EA08-015

**Honda Response to Questions Provided by NHTSA December 3, 2009, and  
Follow-up to January 6, 2010 Meeting  
January 18, 2010**

This document responds to questions NHTSA provided to Honda on December 3, 2009 as a follow-up to the reply from Honda to NHTSA's recall request letter. Portions of this response were updated following our January 6, 2010 meeting reflecting the clarification of certain questions and additional testing done by Honda. NHTSA's questions are restated in **bold** text for identification purposes.

## Attachment Q2-2

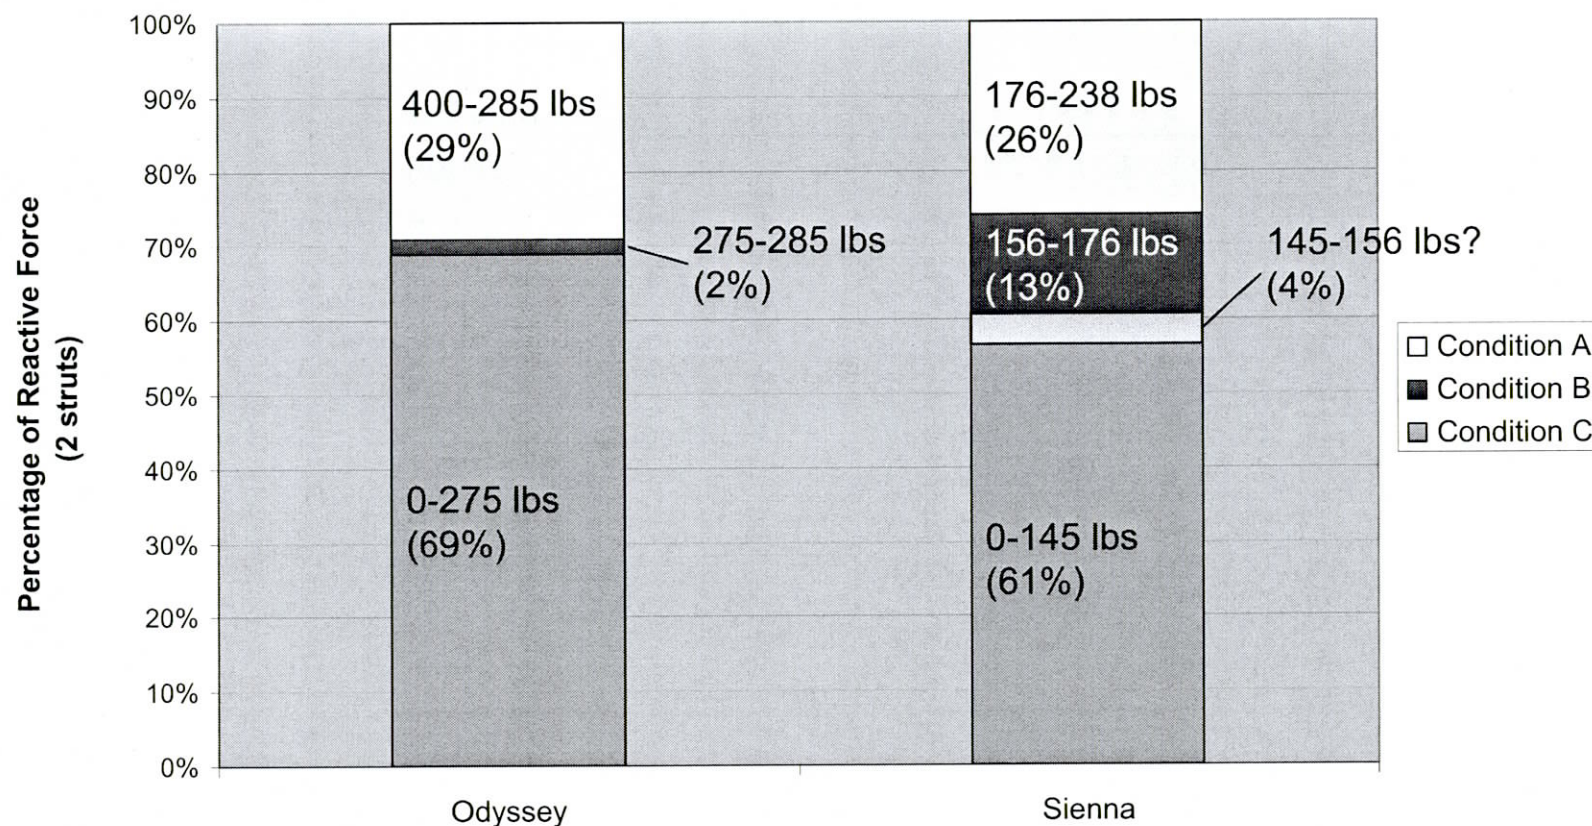
- (1) Explain the note at the bottom left of the table which reads "Method of pinch measurement is the one for power window. We think the load is different as it is equipped with 20N/mm spring."**
- (2) There are significant differences between the measured NHTSA and Honda maximum values for "Pinch sensing load" (293N vs. 170N) for the Odyssey model. Can Honda provide any insight as to why this is (is this due differences in measurement method, process, other?). Does this also explain the differences shown in the Sienna column?**
- (3) What does the row labeled "Range for pinch sensing" mean?**

**Response (1):** When VRTC measured the value for "Pinch sensing load", a piece of dummy "skin" was placed on the sensor. However, when Honda measured the value for "Pinch sensing load", a spring of 20N/mm was equipped on the load cell. Accordingly, Honda considers that the impact load measured by VRTC is higher than the impact load by Honda because the spring constant used by VRTC is also higher than Honda. When a moving object contacts an obstacle resulting in an impact load, the impact force varies depending on the differences in acceleration of the struck object and the deceleration of the striking object. Therefore, there is a difference between the Honda and VRTC measurement values because of variations in the spring rate constant when comparing a load cell affixed to a jig and an object placed on the load cell.

**Response (2):** We have re-tested the "pinch sensing load" in a manner more similar to VRTC, and the results are consistent with VRTC's data. Please find Attachment Q2-2 (a revised version of the earlier Attachment 1) with the updated values. Honda agrees that the condition tested (removal of both gas struts) represents the force measured at a downward angle of 30° from fully open exerted by a liftgate when allowed to drop unimpeded, though we continue to question the likelihood of this condition occurring in the marketplace. This condition would require that both struts completely fail, which we maintain is a condition that would require continued use without repair and is one that has neither been reported to us, nor is it one that we have observed in returned parts.

**Response (3):** In an earlier draft of this document we had included the Ford Freestar in an additional column. Due to the Ford Freestar not being equipped with pinch sensing, that row should have been labeled "Vehicle equipped with pinch sensing" with each cell in the row indicating "yes" for the Odyssey and Sienna and "no" for the Freestar. Due to a translation error and deletion of the column containing information about the Ford Freestar, we apologize that this row did not make sense. This row should have simply indicated that both the Honda Odyssey and Toyota Sienna are equipped with pinch-sensing capabilities.

The red box above reflects revised measurements made on January 12, 2010, using the same 30° down from fully open with both struts removed

## Attachment Q4-1

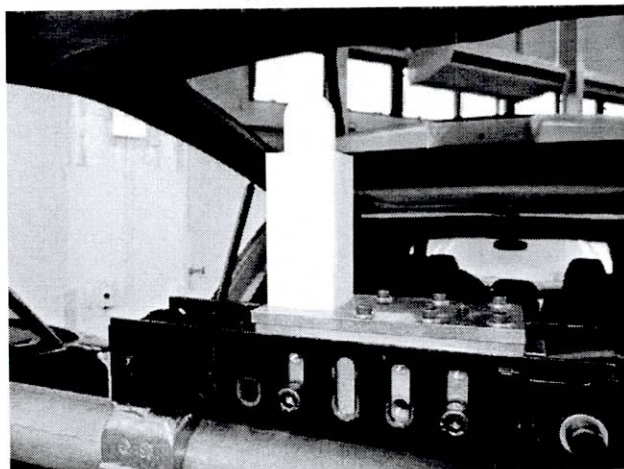
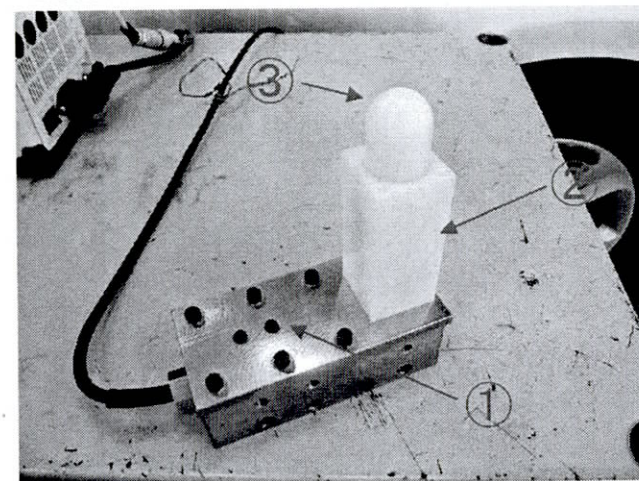
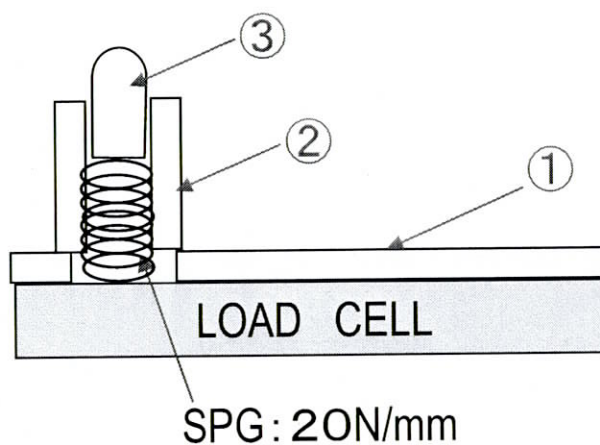
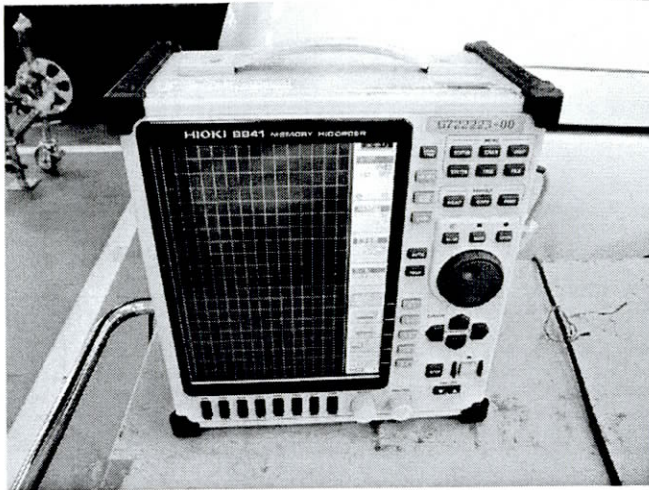
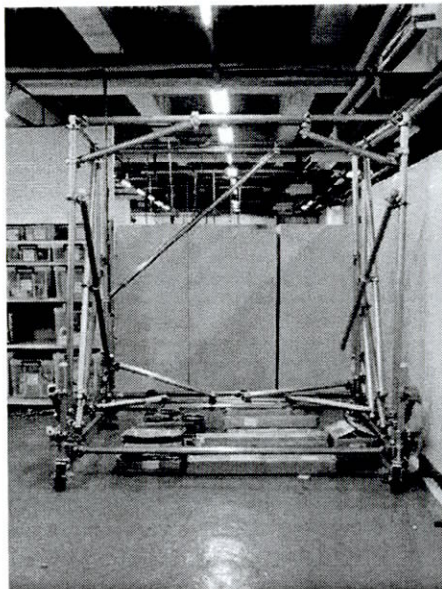
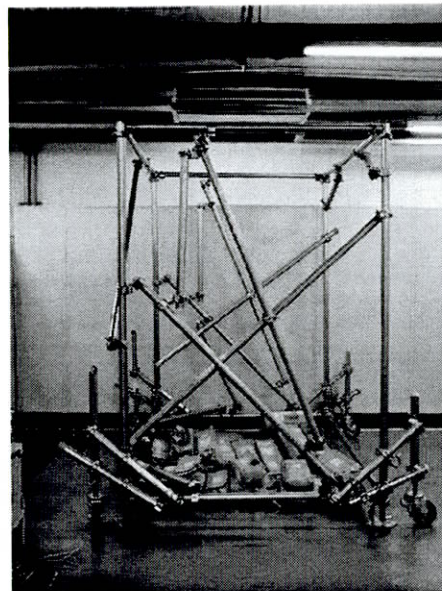
- (1) Verify that Condition "C" should be <275 lb for Odyssey and <145 lb for Sienna (not >275 lb and >145 lb).**
- (2) Provide any insight as to why there are significant differences in the "Height of full open C condition" between the NHTSA and Honda measurements.**
- (3) Provide any insight as to why there are significant differences in the maximum values for the "Load of initial drop" forces between the NHTSA and Honda measurements. Did Honda "filter" or otherwise modify the data from these tests, or is "raw" data?**
- (4) Describe the test protocols for measuring the stated heights/distances and forces, including:**
  - 1. Make, Model and S/N of test equipment (load cell, signal processors, etc.)**
  - 2. Location of the measured forces (e.g., latch cover)**
  - 3. Any pictures and/or video of the test setup and the tests conducted**

1. See attachment Q4-1 for details on the test equipment used by Honda.
2. Measurement location was latch cover, as indicated in attachment Q4-2.
3. See attachment Q4-2 for pictures of test setup and see video for the test conduction.

## Attachment Q5-2: Comparison for the energy conversion during initial drop.

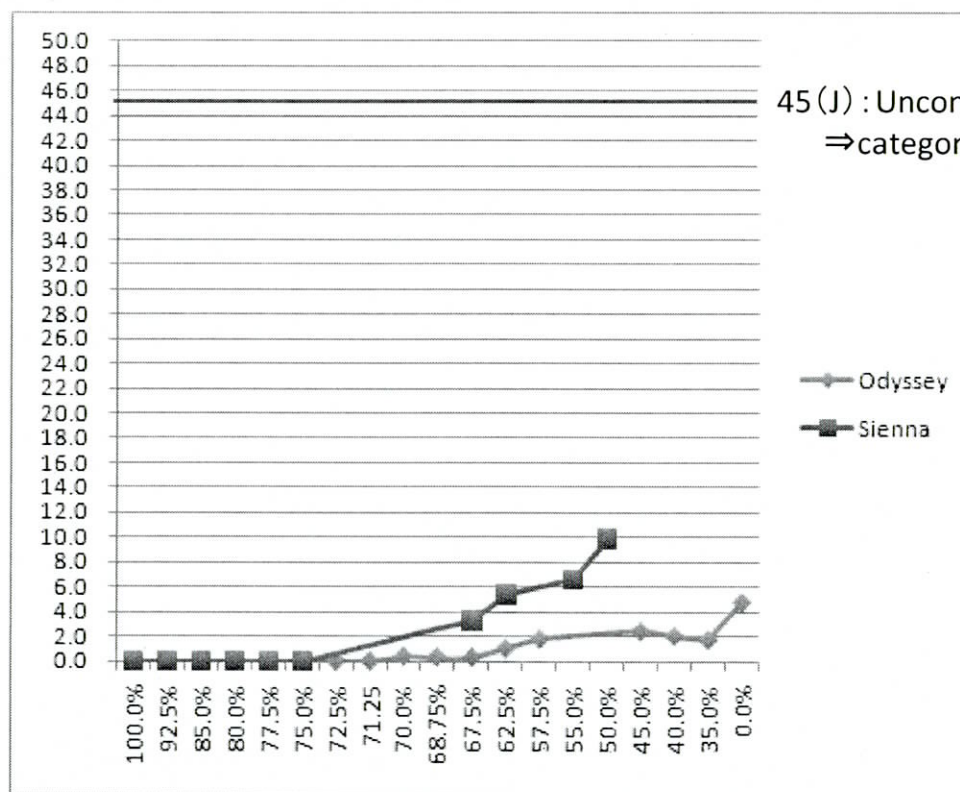
- (1) For calculating the linear velocity of the falling liftgate, why does Honda use the length to be the distance from hinge to the center of gravity?
- (2) Please confirm the revisions from the first to the second version of this document (is it only the change from 2.22 to 22.2)?

**Response (1):** To accurately calculate the energy of the liftgate when closing we determined the distance from the hinge to the center of gravity of the liftgate and measured the angular speed of the closing liftgate.

To calculate the inertial moment of the liftgate, we used the formula:  $E = 0.5(mv^2)$ . We believe this is the standard method of calculating energy in this type of system, and that this formula yields results more representative of real world conditions.

To achieve this, the weight of the liftgate was calculated by determining the load applied to the center of gravity of the liftgate, not by the load applied to the bottom edge of the liftgate. The linear speed at the center of gravity is necessary. To determine the linear speed at the center of gravity, we calculated this value by using the angular speed and the distance from the hinge to the center of gravity.

See Attachment Q5 to find calculations using the Honda our method of determining the energy, and the method used by Toyota in their technical response. By either method it is clear that the relative energy of the Odyssey liftgate falling is significantly less than the Sienna, though both yield values in the non-serious injury range.
